# Mitsubishi Electric AC Servo System

No.16-07AE

### Discontinuation of Using Caution Label (Direction of Diode Installed to Relay for Output Signals) on AC Servo Amplifiers

#### 1. Target Models

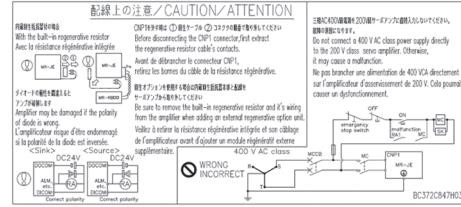
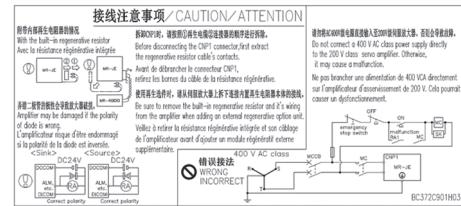
The use of the following caution labels affixed to the servo amplifiers will be discontinued: direction of the surge absorbing diode installed to the DC relay for control output signals, wiring procedures of the regenerative resistor, and inputting incorrect power supply voltage.
